**Application No: 20/V0008/Preapp**  
**Location:** Land north of A4130, Didcot

## **Transport Development Control**

This pre-application seeks specific advice regarding the acceptability of the site access proposals, as well as feedback upon the scoping report, prior to the submissions of the Transport Assessment and Travel Plan.

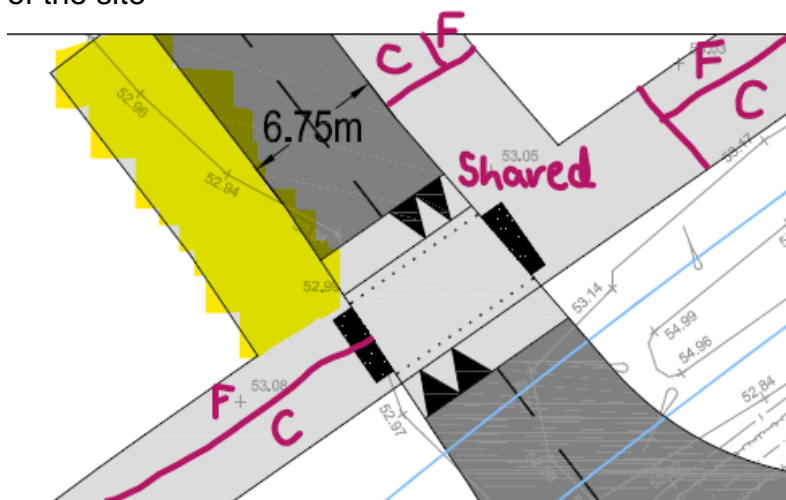
The proposed drawing shown in T20538.001, detailing a ghost right turn arrangement is ok in principal. This proposed layout would be close to a transition from a 30mph zone to a 50mph zone further to the east towards the Collet roundabout and therefore, its layout will have to ensure it takes this into account.

The visibility splays shown in drawing T20538.001, will have to be amended so that the x-distance is 4.5m, to accord with DMRB.

The NMU crossing of the access road, should be made into a parallel crossing so that NMUs maintain the priority and the segregation between pedestrians and cyclists continues.

Drawing T20538.001 shows the NMU provisions reducing as they go into site and para. 3.4 describes how cyclists will enter/leave the carriageway at this point. This is not an acceptable layout, as it will mean cyclists riding on an access road that will be frequently used by HGVs.

The sketch below shows how the layout should be amended for NMUs. The shaded yellow section can be removed, as can the footway provision all the way up the western side of the access road. However, there should be a continuation of the NMU route all the way up through the site, that links in with NC5 in the north-western corner of the site

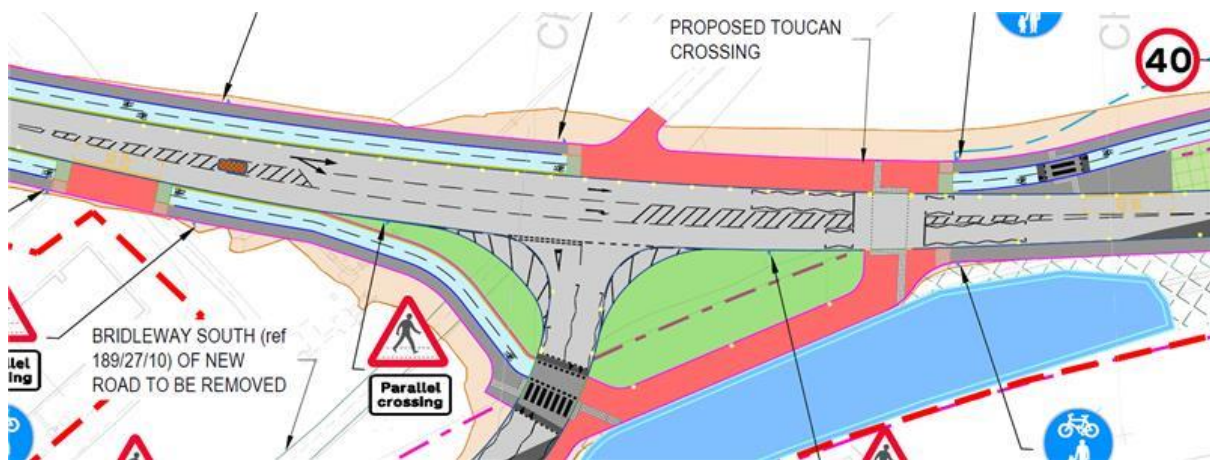
Once this whole A4130 corridor and Culham River Crossing is built out, OCC want to ensure that there is ample opportunity for the NMU to move safely and conveniently through the area, no matter what their origin or destination. To that end, the sketch below, shows the opportunities to establish NMU connections with adjacent routes on the neighbouring land.

There should be a 3m shared route running east to west through the northern part of the site that will link in with the neighbouring D-Tec site and the connection with NC5.

Also, thinking about users coming from the south east wanting to join NC5, OCC require the applicant to provide another 3m shared use path through the site that runs from the south eastern corner.
